BENSON-MONTIN-GREER DRILLING CORP. P&A Procedure and Reclamation Plan

Well Name: EPCMU #22 (C-5) API Number: 30-039-08179 Location: Sec. C-5-T24N-R1E

Re: Permanent Abandonment Well: East Puerto Chiquito Unit 22

CONDITIONS OF APPROVAL

Proposed P&A Wellbore Diagram

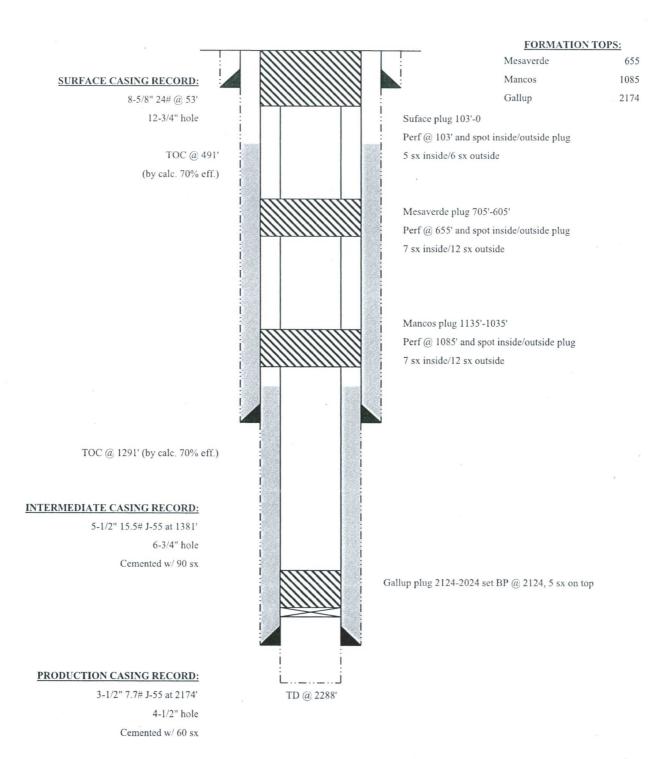
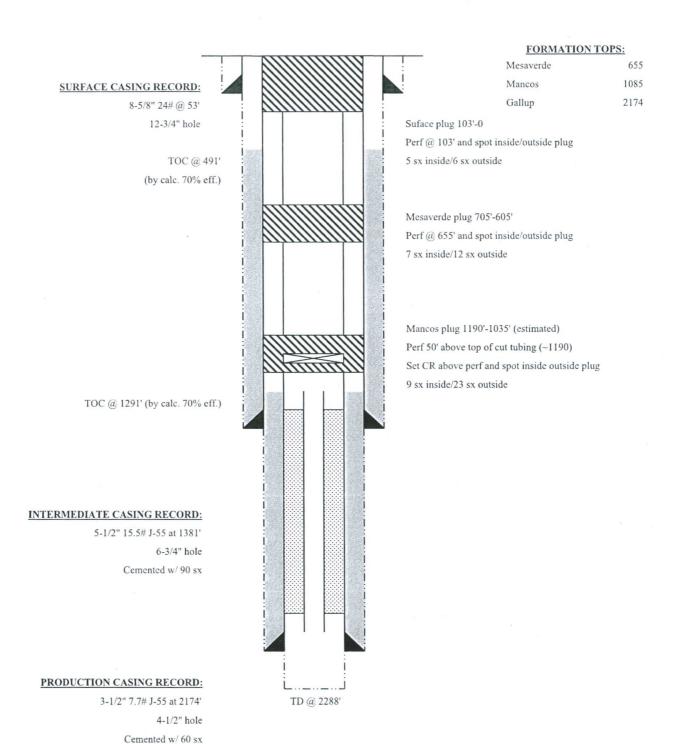
- 1. Plugging operations authorized are subject to the attached "General Requirements for Permanent Abandonment of Wells on Federal and Indian Lease."
- 2. Farmington Office is to be notified at least 24 hours before the plugging operations commence (505) 564-7750.
- 3. The following modifications to your plugging program are to be made:
 - a) Set Plug #1 (1954 1854) ft. to cover the Gallup top. BLM picks top of Gallup at 1904 ft.
 - b) Set Plug #3 (603 503) ft. to cover the Mesaverde top. BLM picks top of Mesaverde at 553 ft.

Operator must run a CBL to verify cement top. Submit the electronic copy of the log for verification to the following addresses: jwsavage@blm.gov brandon.powell@state.nm.us

You are also required to place cement excesses per 4.2 and 4.4 of the attached General Requirements.
